INDESIT company

Model type:
ASD70CEX

Commercial code:
F030643

1270110H Exploded views

N1040358FIG1

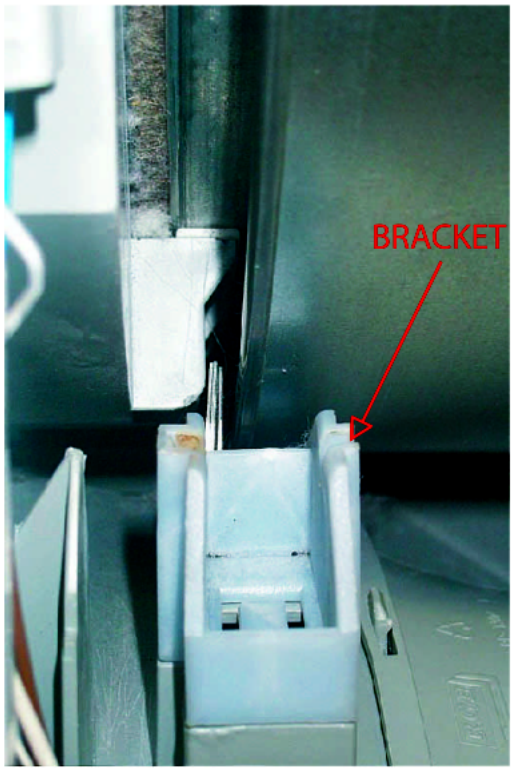
n1040358: Introduction of front bearing pads.

Convert drum front support to run on bearing pads.
Remove the two wheels supporting the drum front from their locating brackets but leaving the two brackets attached to the base assembly. See N1040358FIG1.
Remove the front panel and air duct assembly and fit 5 bearing pads into the locating slots on the air duct assembly. See N1040358FIG2. Replace both the rear bearing and the drive belt to the 6 rib version.

As from s/n 50131.0001 the front suspension changed on production of all condenser dryers from wheels to bearing pads as described above.

Parts needed:
5 X Front Bearing pad code C00112144 item 350
1 X Rear Bearing code C00113862 item 503
1 X Belt code C00116358 item 556

The above parts are available in the kit code C00118931.

N1040369FIG1

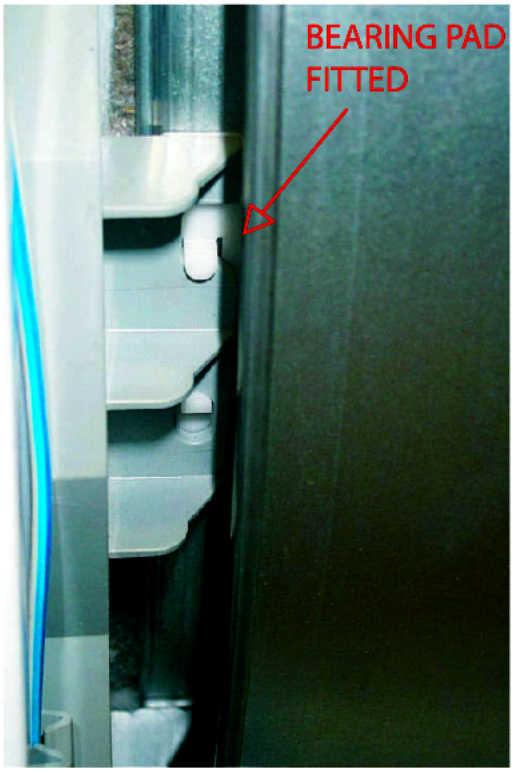
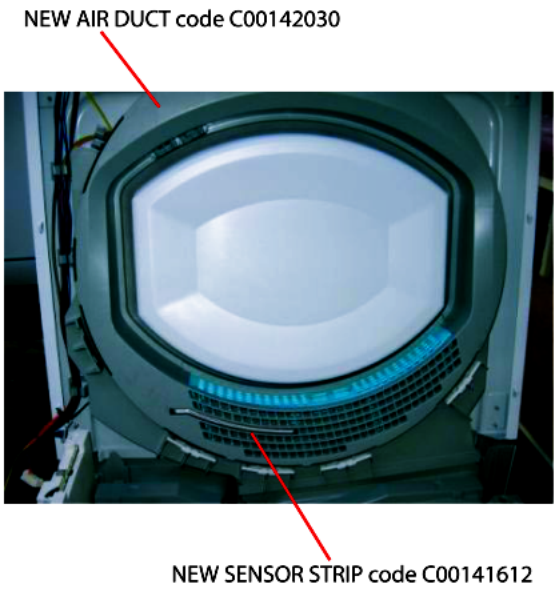
n1040369: Sensor, heating element and thermostat modified on condenser dryers.

From serial no. 50712.0001, the following parts have been introduced progressively on condenser dryers:
- new sensor (figure N1040369FIG1);
- new heating element;
- new thermostat.

The eeprom and circuit diagram were also affected by the modification (Figure N1040369FIG2).

The new items are not interchangeable with the premodification ones.

New parts:
C00142030 - front air duct - (ref.330)
C00141612 - sensor strip - (ref.330)
C00141607 - drum support (there are 2 on all dryers) - (ref.545)
C00142303 - heating element - (ref.522)
C00142302 - heating element for ASL70CSK - (ref.522)
C00142587 - heating element for ISL70CSK - (ref.522)
C00141606 - thermostat kit - (ref.521)
C00142300 - thermostat kit for ASL70CSK - (ref.521)

The replacement eeprom codes and relevant serial number are listed below.
New C00142039 - premodification C00115756 - s/n 50809.0001 - cc 33620 - ADE70CFR
new C00119909 - premodification C00114814 - s/n 50712.0001 - cc 33619 - ALE70CFR
new C00119912 - premodification C00115751 - s/n 50801.0001 - cc 30643 - ASD70CEX
new C00119914 - premodification C00114817 - s/n 50801.0001 - cc 30645 - ASL70CEX
new C00119915 - premodification C00114816 - s/n 50712.0001 - cc 30648 - ASL70CSK
new C00142040 - premodification C00114838 - s/n 50722.0001 - cc 30621 - ISL65CEX
new C00142041 - premodification C00114822 - s/n 50804.0001 - cc 30624 - ISL70CEX
new C00142042 - premodification C00114832 - s/n 50811.0001 - cc 30622 - ISL70CNL
new C00142043 - premodification C00142582 - s/n 50810.0001 - cc 30625 - ISL70CSEX
new C00142044 - premodification C00119971 - s/n 50816.0001 - cc 34178 - ISL66CXEX
new C00142588 - premodification C00114834 - s/n 50802.0001 - cc 30627 - ISL70CSK

N1040400FIG1

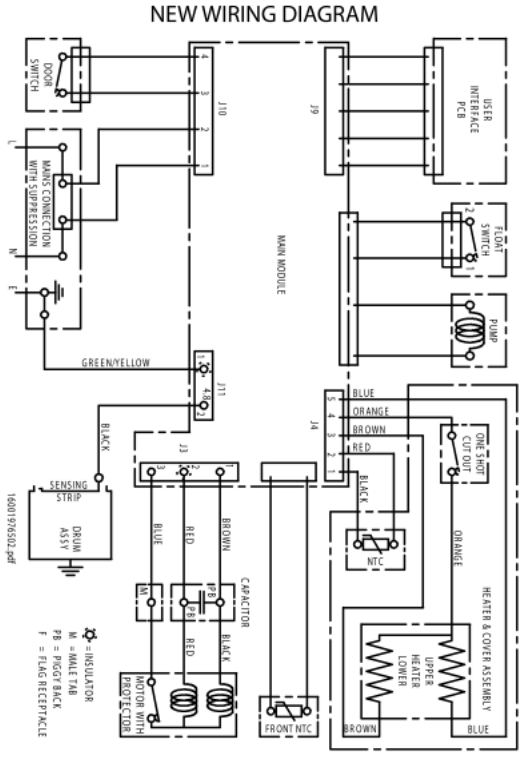
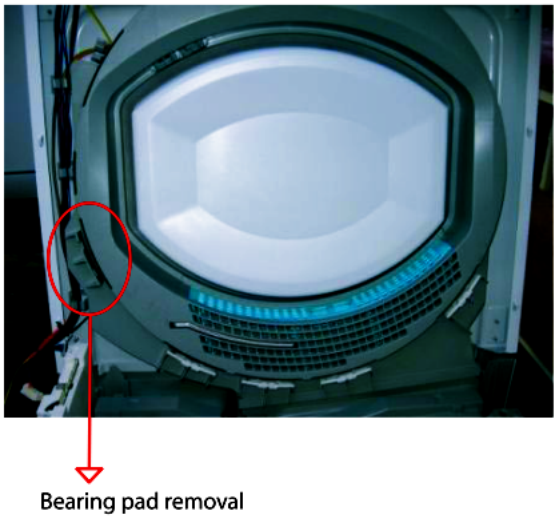
n1040400: Bearing pad removed from condenser dryers.

From serial no. 51031.0001, four bearing pads (C00112144) have been installed on dryers instead of five (see figure N1040401FIG1).

From 30.01.10 the front air duct assembly will be modified by removal of the 5th bearing pad fixing

N1040411FIG1

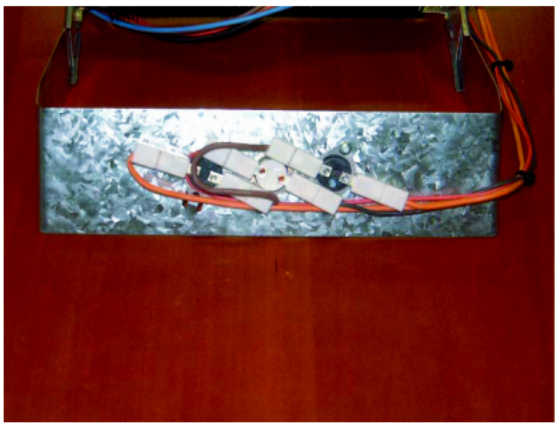
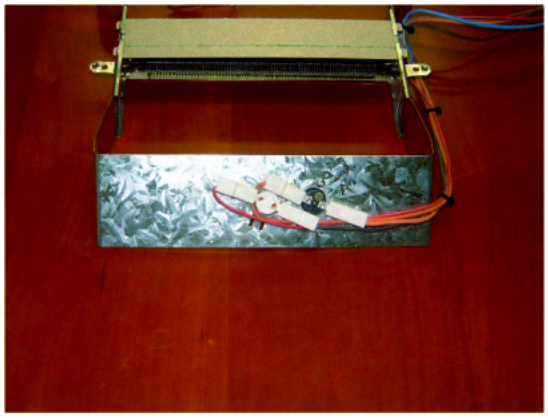
1) All appliances with serial number prior to 50712.0001 are equipped with a heating element assembly (fig1) with the following thermostats:
a) one-shot
b) cycling
c) ntc

2) From serial no. 50712.0001 the cycling thermostat has been eliminated, the heating element assembly (fig.2) is composed of the following thermostats:
a) one-shot
b) ntc

3) From serial no. 51130.0001 the ntc thermostat has been modified, the modification also introduced a new eeprom with software 28XXXXX0008, the heating element assembly (fig.2) is composed of the following thermostats:
a) one-shot
b) ntc (Tod)

4) From serial no. 60109.0001 the cycling thermostat has been reintroduced, the heating element assembly (fig.1) is composed of the following thermostats:
a) one-shot
b) cycling
c) ntc (Tod)

Replacement P/Ns for models with serial number prior to 51130.0001:

C00258828 - heating element assembly (with one-shot + cycling + ntc sensor)
C00258813 - heating element assembly (with one-shot + cycling + ntc sensor) for SK dryers
C00116598 - thermostat kit (one-shot + cycling)
C00113830 - ntc thermostat
Important
When replacing the thermostats on models with serial numbers from 50712.0001 to 51130.0001 order the assembled heating element.

Replacement P/Ns for models with serial number subsequent to 51130.0001:
C00258799 - heating element assembly (with one-shot + cycling + new ntc sensor)
C00258800 - heating element assembly (with one-shot + cycling + new ntc sensor) for SK dryers
C00116598 - thermostat kit (one-shot + cycling)
C00143511 - ntc thermostat (new Tod)
Important
When replacing the thermostats on models with serial numbers from 51130.0001 to 60109.0001 order the assembled heating element.
